SUBJECT: CONCEPT PLAN REVIEW – 1301 COURTESY RD /
1390 CANNON ST, DELO BOOM (WEST)

DATE: FEBRUARY 6, 2024

PRESENTED BY: MATT POST, SENIOR PLANNER - COMMUNITY
DEVELOPMENT

SUBJECT: DELO BOOM CONCEPT PLAN REVIEW

CONCEPT SITE PLAN

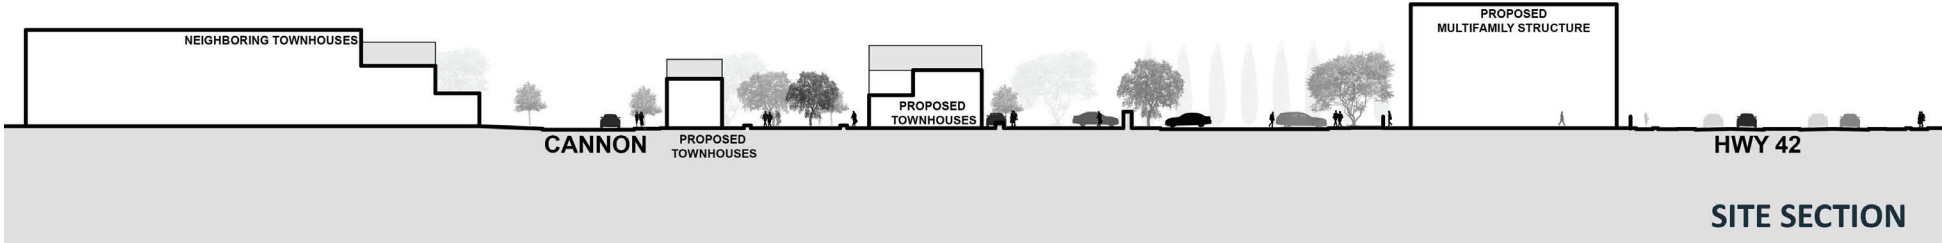
- **Density:** The applicant will request consideration of a waiver to the maximum residential density allowed. [Sec. 17.14.160 of the LMC](#) limits residential uses in the MU-R zone district to 20 units per acre. The Concept Plan shows 25 units per acre. The applicant states that permitting more units on site will allow the development to include inclusionary housing pursuant to the requirements of [Sec. 17.76](#) of the LMC.

- **Building Area:** The applicant will request consideration of a Special Review Use to allow a building footprint of greater than 10,000 square feet. Pursuant to [Sec. 17.14.160 of the LMC](#), the maximum ground floor building footprint in the MU-R zone district is 10,000 square feet. The proposed multifamily building exceeds 10,000 square feet. Special Review Uses are evaluated against the review criteria found in [Sec. 17.40.100 of the LMC](#). A Special Review Use shall be referred to the Planning Commission for recommendation and approved by the City Council.

- **Building Height:** The applicant will request consideration of a waiver to decrease the minimum building height. In accordance with [Sec. 17.14.160 of the LMC](#), the minimum building height in the MU-R zone district is 35 feet and two-stories. The applicant is proposing two-story townhouses that are less than 35 feet in height.

- Inclusionary Housing – the applicant has indicated that providing the total number of required inclusionary units on-site may be a challenge with current density limitations and Energy Code requirements, though have indicated their intent to provide the required percentage of on-site units.
- Transportation Improvements – a traffic study submitted with a formal land use application will inform the scope of required transportation infrastructure improvements and any additional street connection requirements.
- Architectural Massing and Building Design – final building massing, design, and heights will be a key item to review against the MUDDSG.

Key Issues to Consider

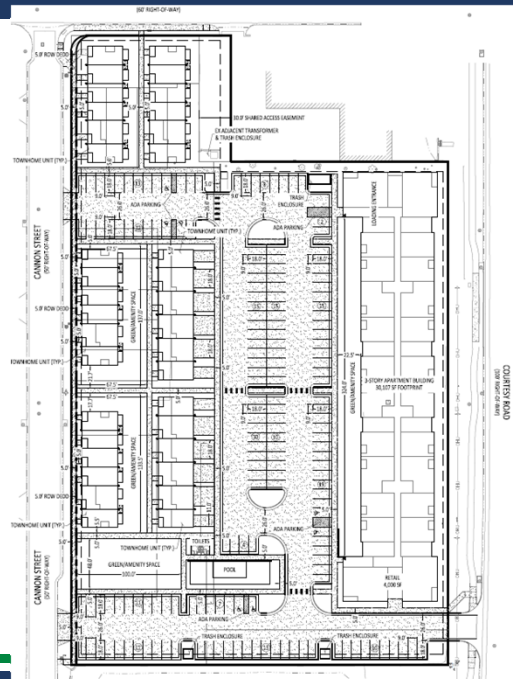
- Density:** The applicant will request consideration of a waiver to the maximum residential density of 20 units/acre allowed in the MU-R zone district. The applicant is requesting 25 units/acre. The applicant asserts that permitting more units on site will allow the development to include inclusionary housing pursuant to the requirements of [Sec. 17.76](#) of the LMC.

Key Issues to Consider

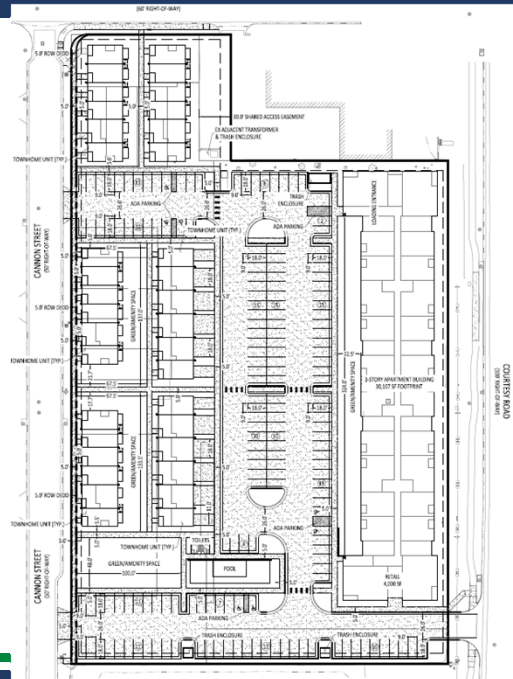
- Building Area:** The applicant will request consideration of a Special Review Use to allow a larger-than-permitted building footprint. The maximum ground floor building footprint in the MU-R zone district is 10,000 square feet – the proposed apartment is +/- 30,000 square feet.

Key Issues to Consider

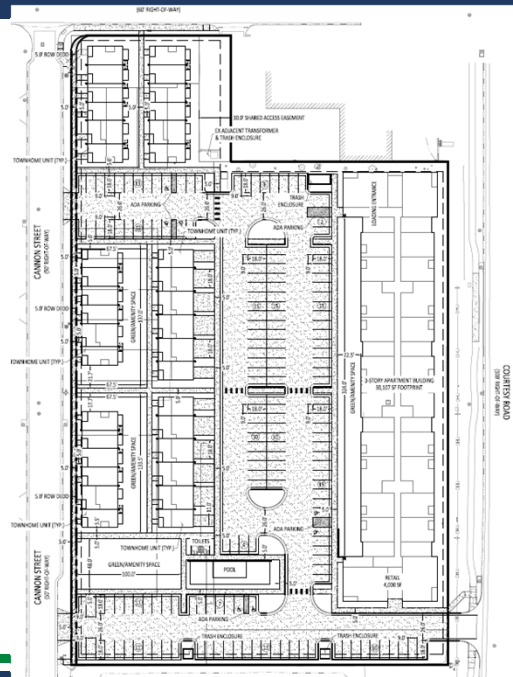
- **Building Height:** The applicant will request consideration of a waiver to decrease the minimum allowed building height. The minimum building height in the MU-R zone district is 35 feet and two-stories. The applicant is proposing two-story townhouses that are less than 35 feet in height.
